Review of Noise Study

Record Hill Wind, LLC.

Submitted: February 18, 2009

The People's Task Force on Wind Power

Figure 1-Graph from 1990 NASA Wind turbine Acoustics report by Hubbard and Sheperd showing that the sound from ridge mounted turbines propagates at 3 dB per doubling of distance and that the rate of 6 dB per doubling of distance does not occur until a mile or more from the ridge top.

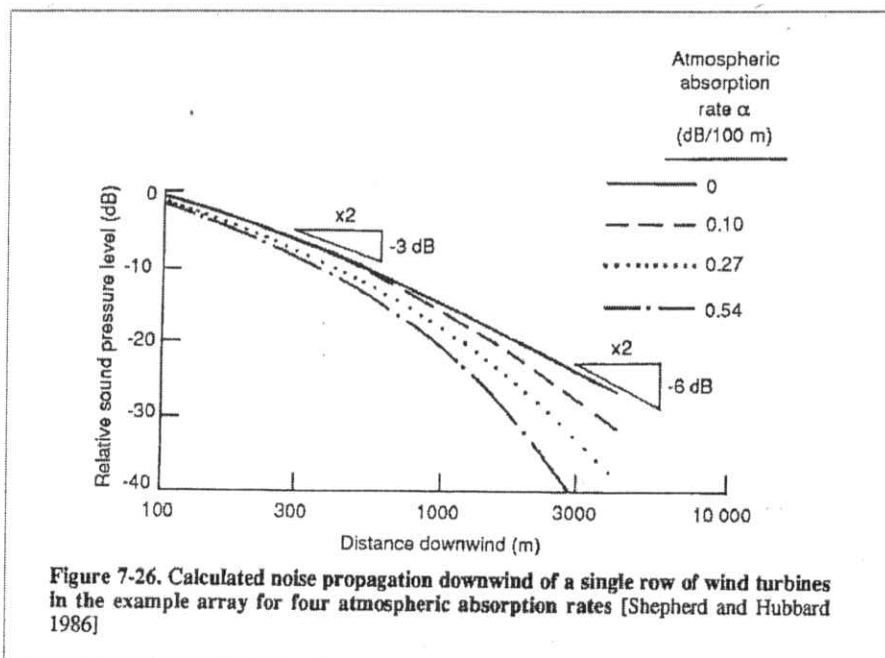
However, these anomalies are not the primary deficiency of the model used for RHW. Inspection of the contours representing sound propagation from the turbines to the properties adjacent the project show that the model assumed that the sound levels from the turbines to the receiving locations decay at the rate of 6 dB per doubling of distance. Thus, the model shows that the operational sound levels of the turbines comply with the MDEP rules for nighttime noise at Roxbury Pond and the south end homes.

This is reinforced in the narrative of the RHW study where on page 38 it states: "For every doubling of distance from a stationary hemispherical noise source, the sound level drops by 6 dB. Thus if the sound level is 50 dBA at 500 feet, the sound level at 1000 feet will be 44 dBA, and will be 38 dBA at 2000 feet."

But, this is not the appropriate decay rate for sound from ridge mounted turbines. The appropriate decay rate for ridge mounted turbines is 3 dB per doubling of distance until the receiver locations are about a mile or two away from the ridge.

This has been known as far back as 1990 when a research project conducted for NASA studies wind turbine sound propagation. The graph below (Figure 1) shows the NASA study's graphic illustrating where models should use the 3 dB decay rate and the 6 dB decay rate. The RHW study is in error in its construction and this error will lead to underestimates of the sound levels in the areas around the wind project.

The degree of this error is considerable. The RHW figure showing the sound levels as contours has three major lines. One bold green line for 55 dBA impacts, a bold blue line for 45 dBA and a third bold green line for 35 dBA. If the proper decay rate was applied by this model the sound level at the 45 dBA line would be 50 dBA or higher. The 35 dBA line that extends into Roxbury Pond would be 45 dBA. Thus, the results of a model based on well understood rules for how sound propagates from ridge mounted wind turbines severely under predict the impact of the project on the community. The model should have shown the sound levels along the west side of the ridge near Roxbury Pond as exceeding the MDEP nighttime limits of 45 dBA and at the homes near the south end the sound levels would be similarly higher than permitted at night under the MDEP rules.
